PREVOST

WARRANTY BULLETIN

WB15-38A

DATE :	AUGUST 2015	SECTION :	23 - Accessories
EXPIRATION:	AUGUST 2017		
SUBJECT :	WASHER FLUID HOSE SUPPORT

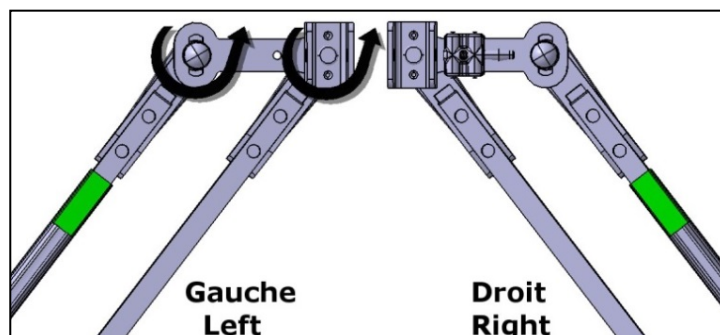
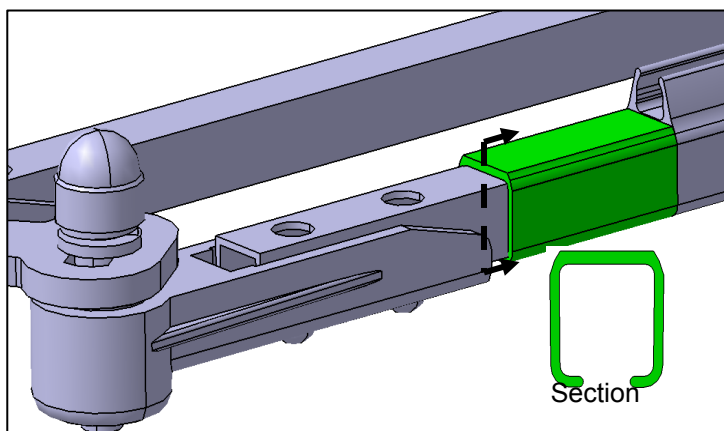
On the vehicles affected by this bulletin, add an extrusion to the wiper arms to support the washer fluid hose.

For each wiper parallelogram assembly, install one extruded spacer #300642, Qty 2 on the arm having the washing fluid hose.

Important: Orient as shown, with slot underneath.
